Annex 135B

Chip-to-Chip 50 Gb/s 2-lane Attachment Unit Interface (LAUI-2 C2C)

Comment #116: Proposed change to LAUI-2 C2C (similar changes to be applied to all C2C annexes)

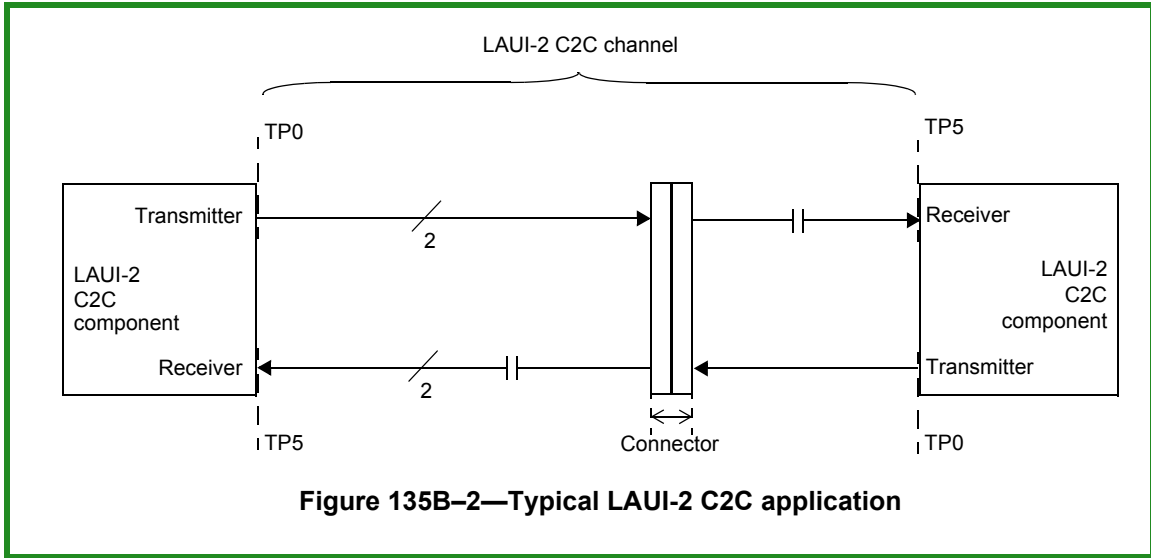
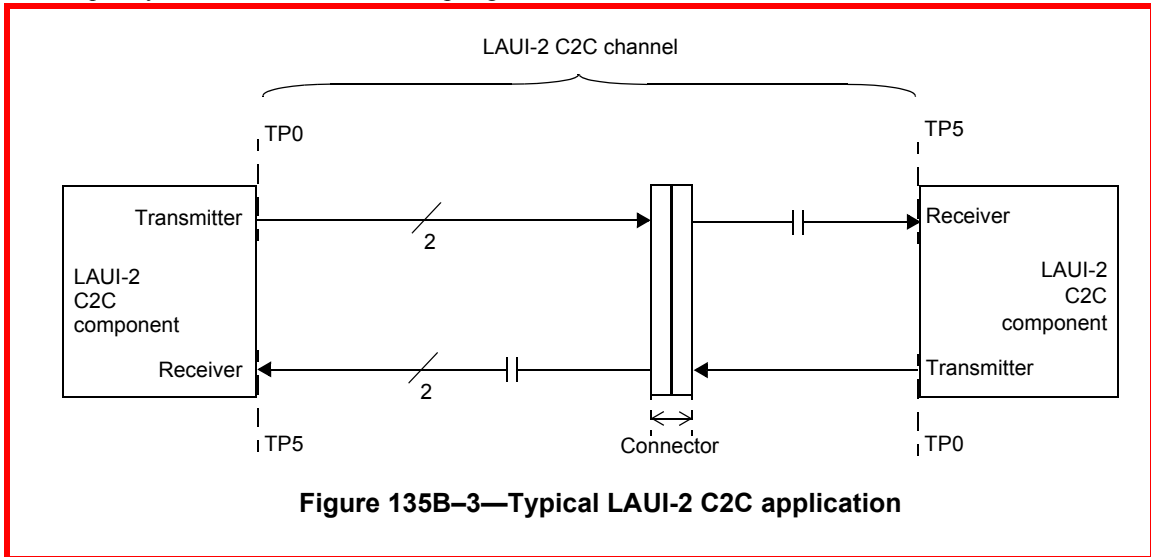
The LAUI-2 C2C bidirectional link is described in terms of a LAUI-2 C2C transmitter, a LAUI-2 C2C channel, and a LAUI-2 C2C receiver. Figure 135B-3 depicts a typical LAUI-2 C2C application.

Paragraph break to put the figure after its reference (the rest of the paragraph is detail)
